Russell City Energy Center

Amendment No. 4

California Energy Commission

November 2012

VISUAL RESOURCES - FIGURE 4

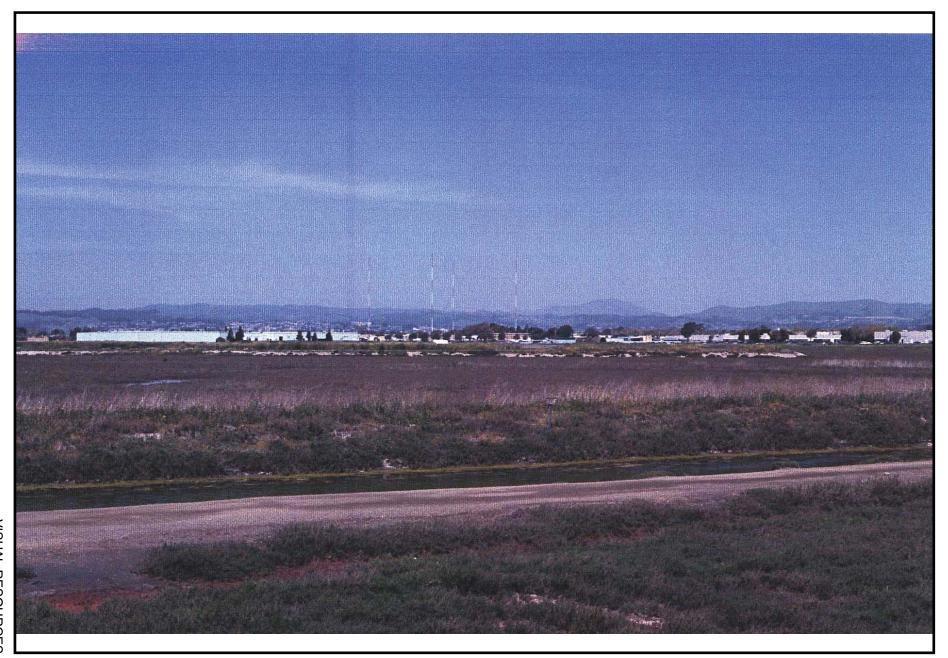
See Visual Resources Figure 1 – Google Earth Image Showing Location of the Russell City Energy Center and the Hayward Shoreline Interpretive Center, Visual Resources Figure 2 – Aerial View of Russell City Energy Center Under Construction, Visual Resources Figure 3 -View of Russell City Energy Center Under Construction in the City of Hayward "Industrial Corridor" from San Francisco Bay Trail in the Hayward Regional Shoreline, and Visual Resources Figure 4 – View of the "Industrial Corridor" South of the Russell City Energy Center from San Francisco Bay Trail.
